PIC24FJ256GB110 Family Silicon Errata and Data Sheet Clarification

The PIC24FJ256GB110 family devices that you have received conform functionally to the current Device Data Sheet (DS39897C), except for the anomalies described in this document.

The following typographic corrections and clarifications are to be noted for the latest version of the device data sheet (DS39897C):

FIGURE 2-3 FREQUENCY vs. ESR PERFORMANCE FOR SUGGESTED VCAP

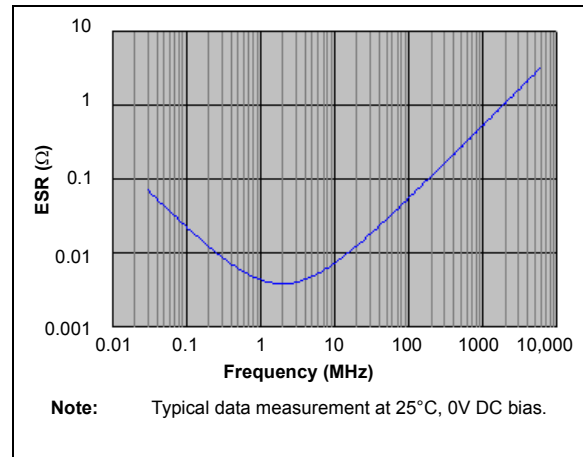
Section 2.4 Voltage Regulator Pins (ENVREG/DISVREG and VCAP/VDDCORE) has been replaced with a new and more detailed section. The entire text follows:

When the regulator is enabled, a low-ESR ($< 5\Omega$) capacitor is required on the VCAP/VDDCORE pin to stabilize the voltage regulator output voltage. The VCAP/VDDCORE pin must not be connected to VDD and must use a capacitor of 10 μF connected to ground. The type can be ceramic or tantalum. Suitable examples of capacitors are shown in [Table 2-1](#). Capacitors with equivalent specifications can be used.

Designers may use [Figure 2-3](#) to evaluate ESR equivalence of candidate devices.

FIGURE 2-4 DC BIAS VOLTAGE vs. CAPACITANCE CHARACTERISTICS

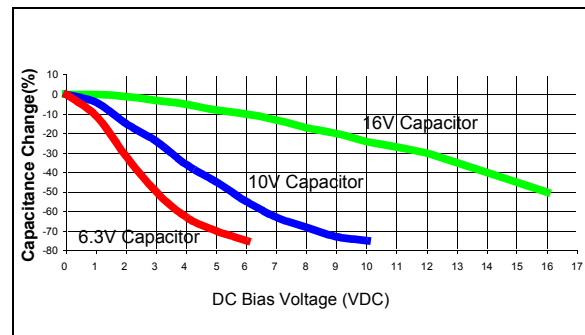
A typical DC bias voltage vs. capacitance graph for 16V, 10V and 6.3V rated capacitors is shown in Figure 2-4.

When selecting a ceramic capacitor to be used with the internal voltage regulator, it is suggested to select a high-voltage rating, so that the operating voltage is a small percentage of the maximum rated capacitor voltage. For example, choose a ceramic capacitor rated at 16V for the 2.5V core voltage. Suggested capacitors are shown in Table 2-1.

FIGURE 29-1: PIC24FJ256GB110 FAMILY VOLTAGE-FREQUENCY GRAPH (INDUSTRIAL)

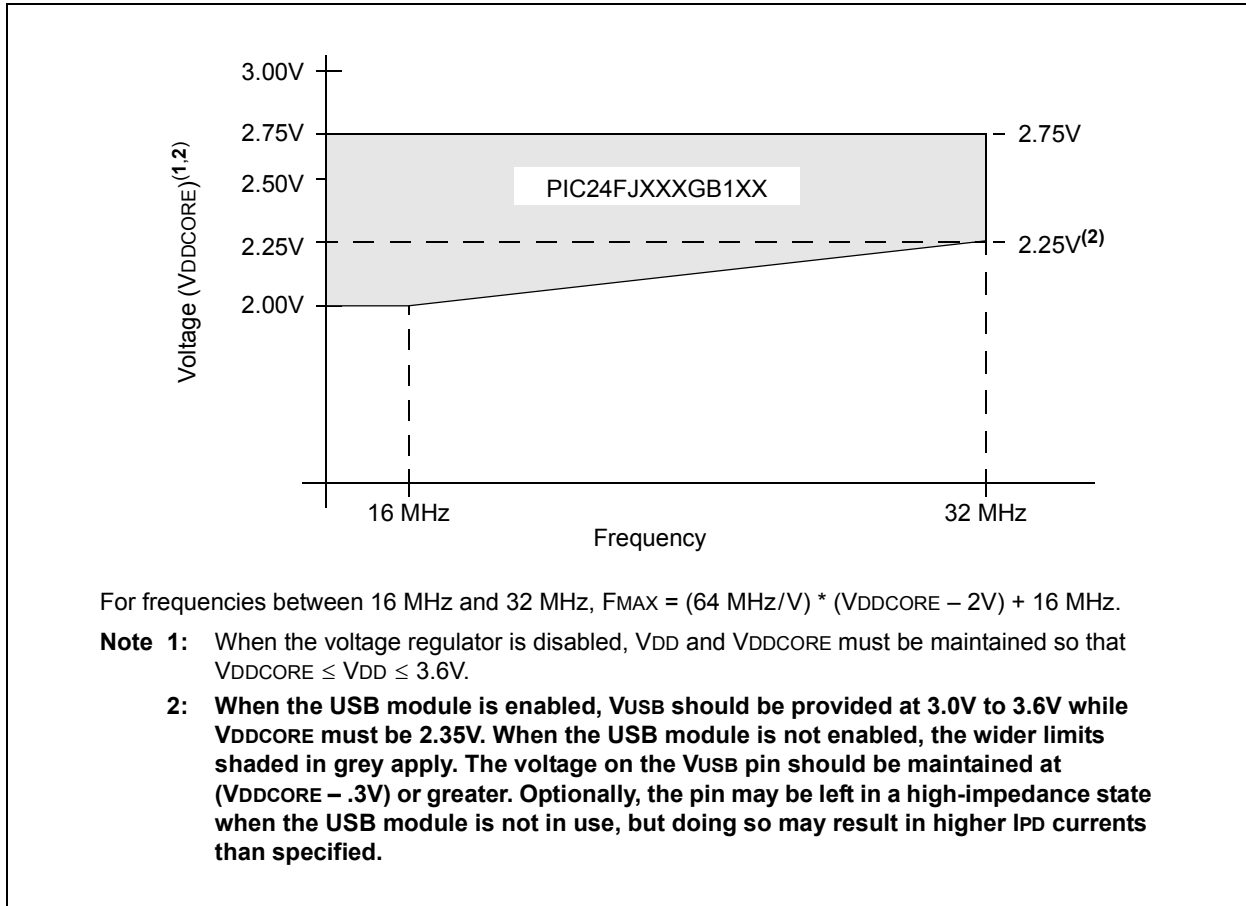
Figure 29-1 (“PIC24FJ256GB110 Family Voltage-Frequency Graph”) is amended by adding an additional footnote. The updated figure is shown below (changes in **bold**; bold in original removed for clarity).
